AGREEMENT

WHEREAS, the CRA desires to retain the services of the Contractor to provide the goods and services in accordance with the CRA's Invitation to Bid No. 2022-01-R, and the Contractor's response thereto, all of which are incorporated herein by reference.

ENLARGED STAIR FLOOR PLAN

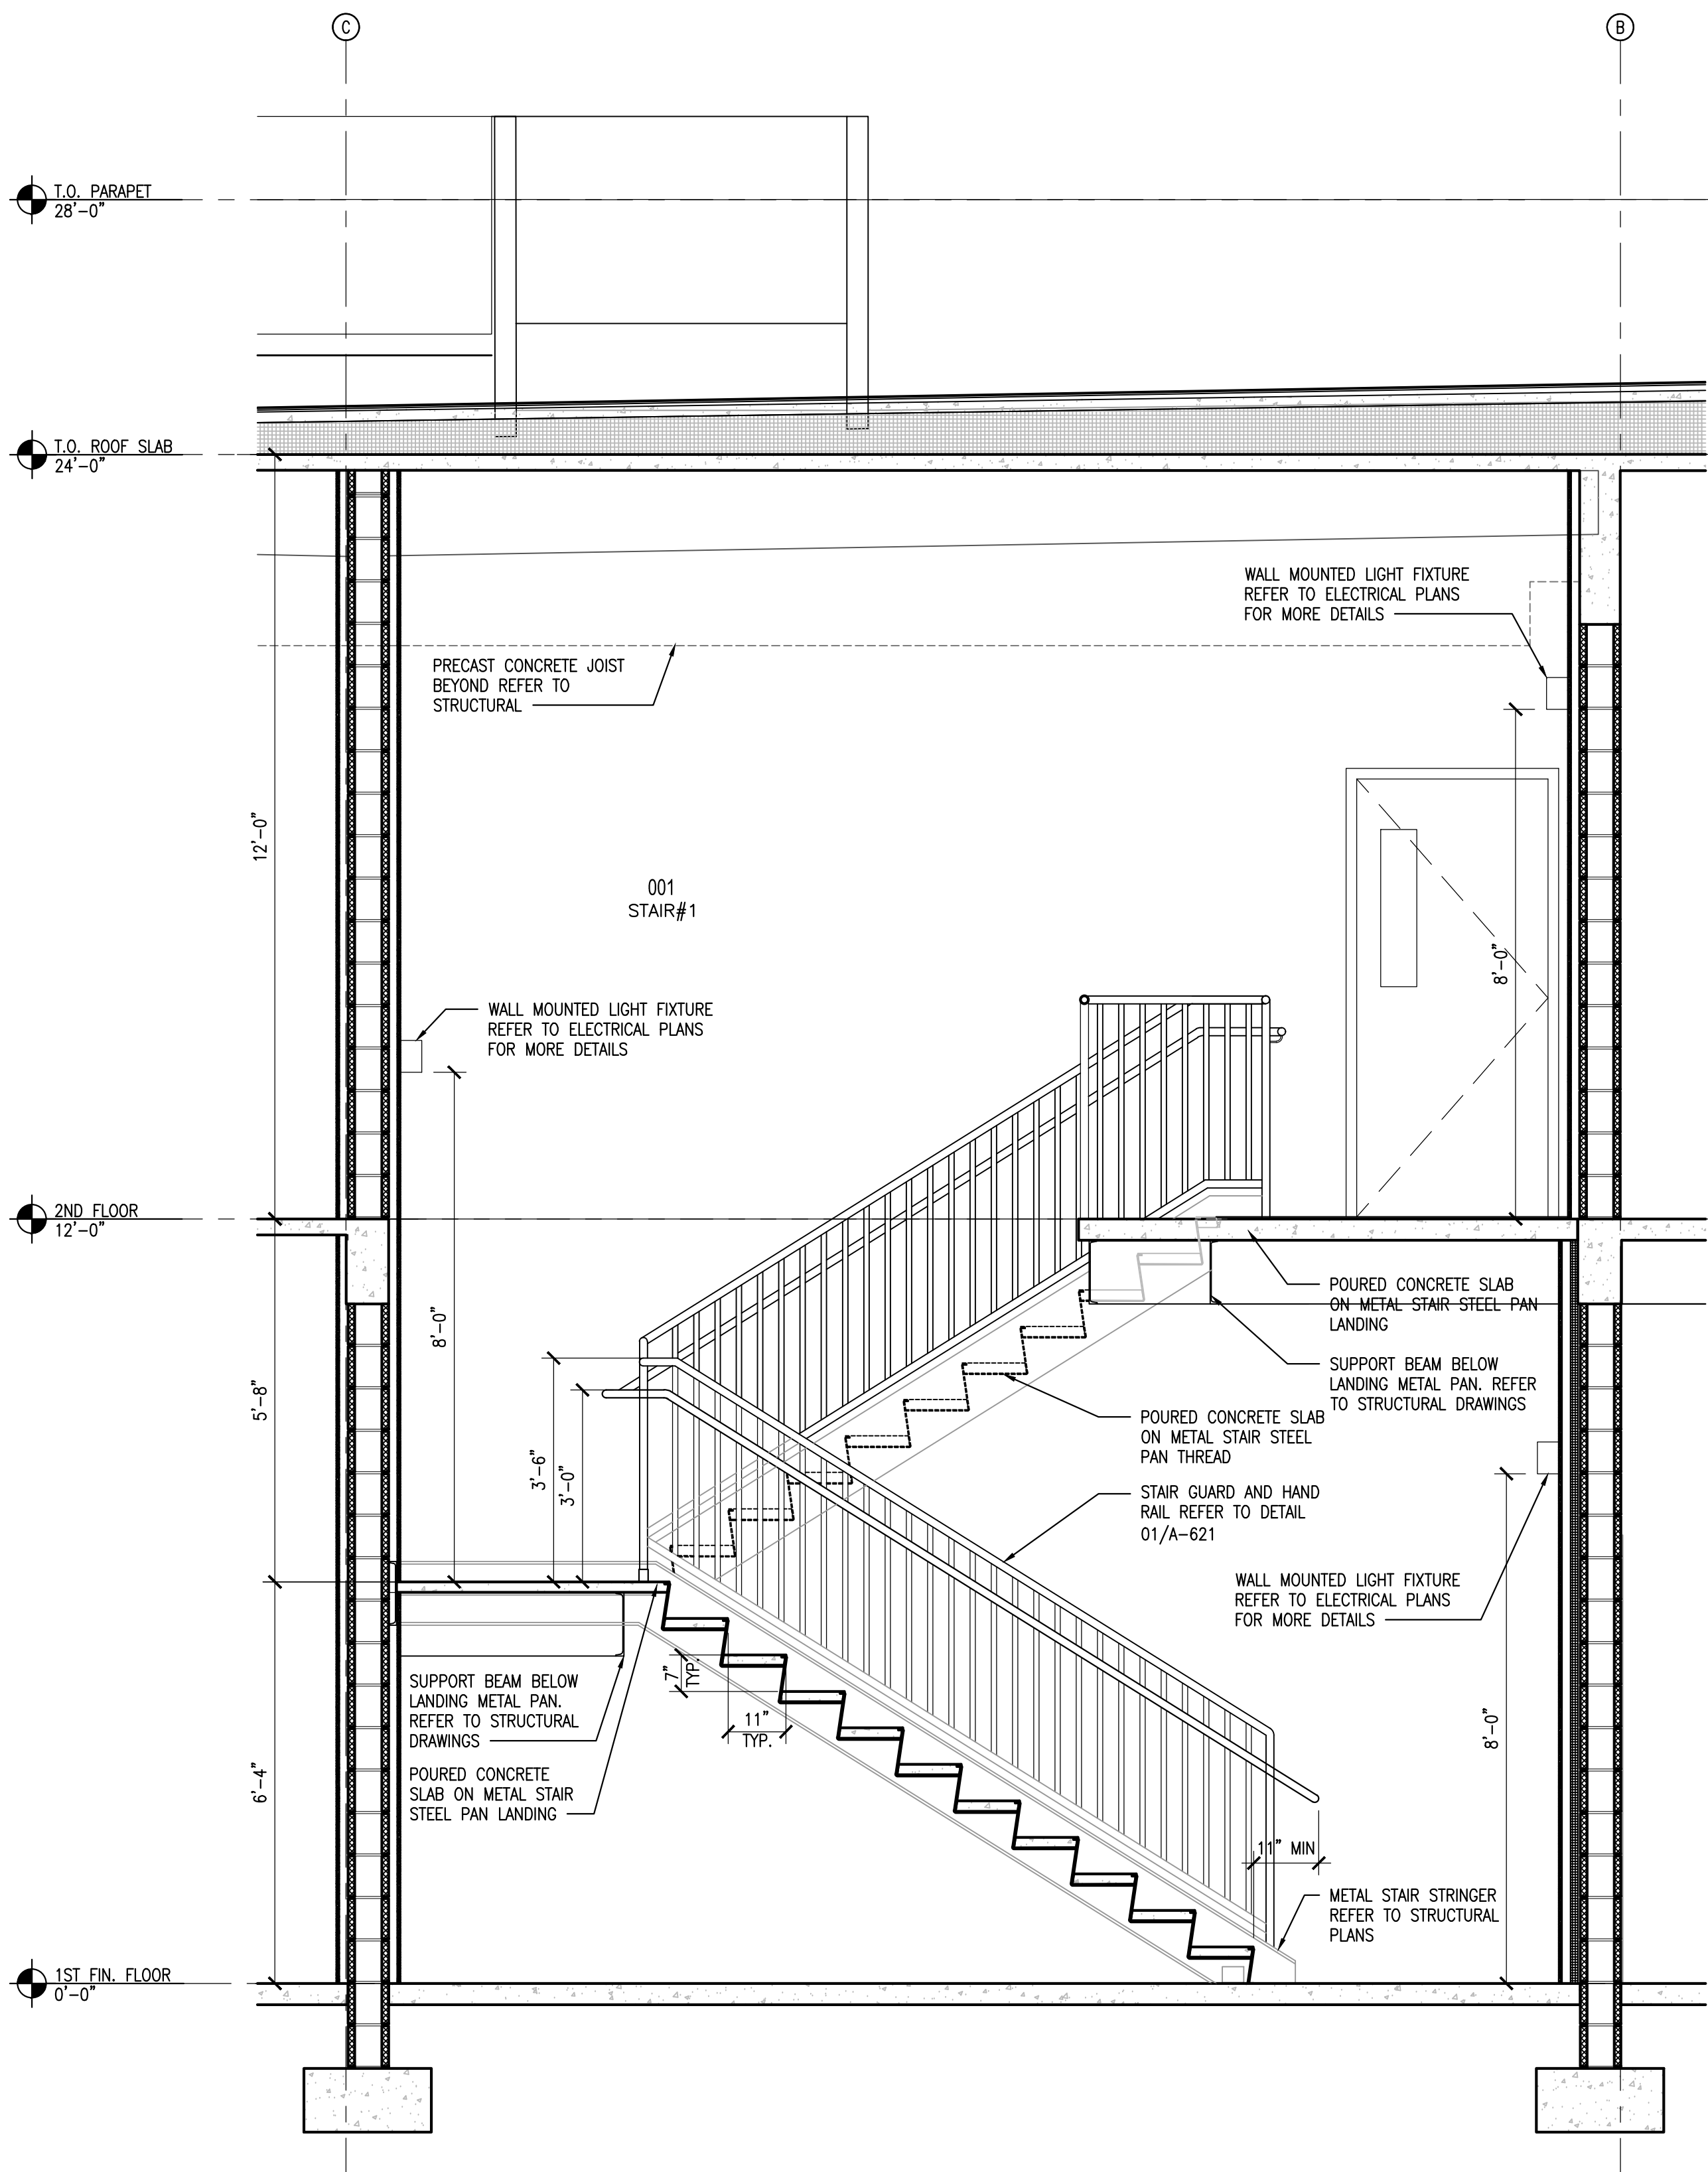
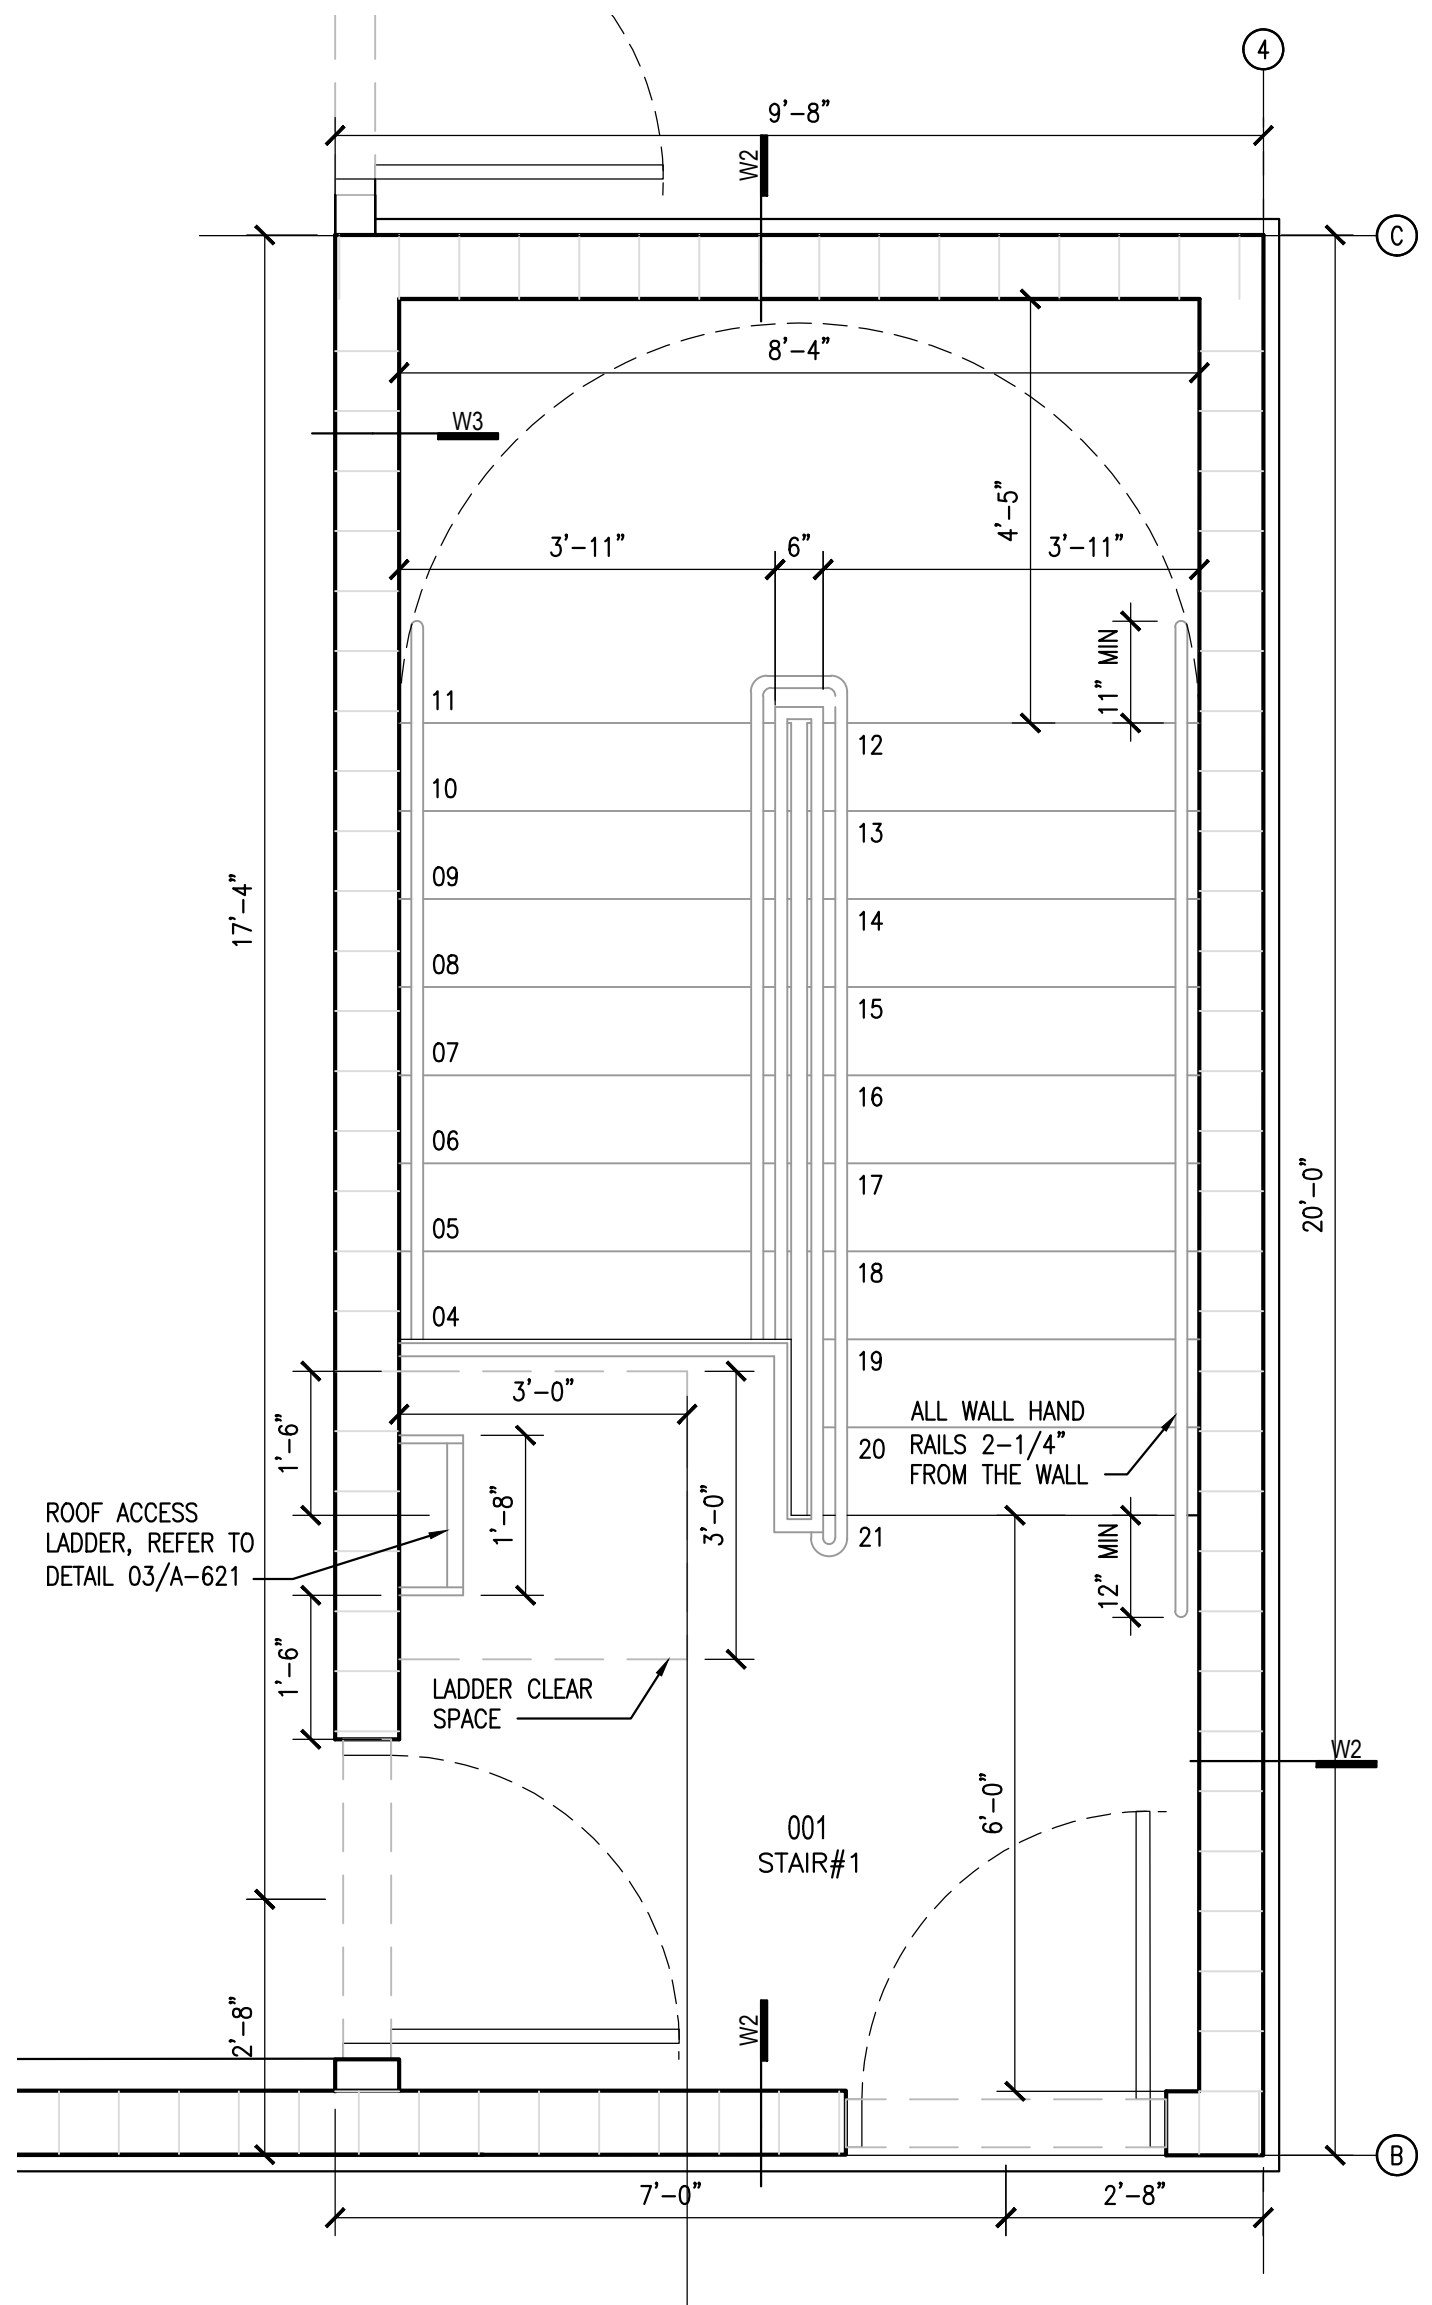
15. **There is no support beam at the 2nd floor stair landing (sheet S.20), but a support beam shows on (sheet A-620). Please clarify.**

Sheet A-620 shows part of metal pan stair. The metal pan stair and landing are pre-engineered. Please refer to specification section #05 51 00 for details on the metal pan stairs (page 108 of the Specification file).
